SERVICE BULLETIN

SERVICE BULLETIN		No.: MSB-99E23-002	
		Date: 1999-12-15	
Subject: CHANGE IN TRANSFER DRIVE GEAR DISASSEMBLY/REASSEMBLY PROCEDURE		<Model>	<M/Y>
Group: AUTOMATIC TRANSAXLE		(EC) COLT (CJ0A)	98-10
		(EC) LANCER (CK0A)	98-10
		(EC) CARISMA	98-10
		(EC) GALANTE (EA0)	98-10
		(EC) SPACE RUNNER	98-10
		(N61W)	98-10
		(EC) SPACE WAGON	
		(N84W)	
INFORMATION	INTERNATIONAL CAR ADMINISTRATION OFFICE	 T.NITTA - PROJECT LEADER AFTER SALES SERVICE & CS PROMOTION

Shape of lock nut

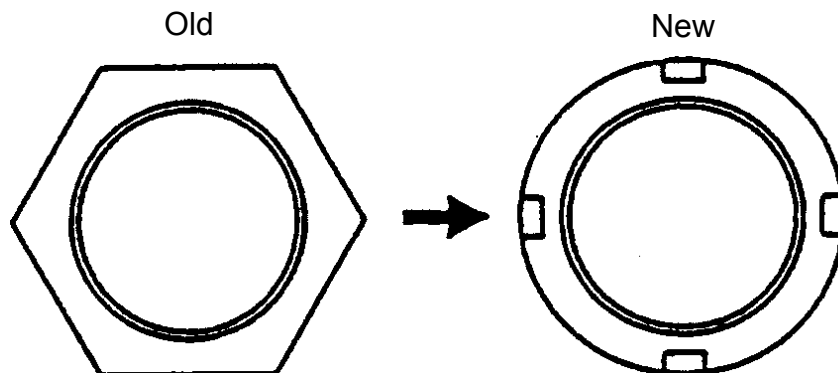
With change in shape of the lock nut, the transfer drive gear has been changed to that which cannot be disassembled. Accordingly, the applicable transfer drive gear service procedure has been added.
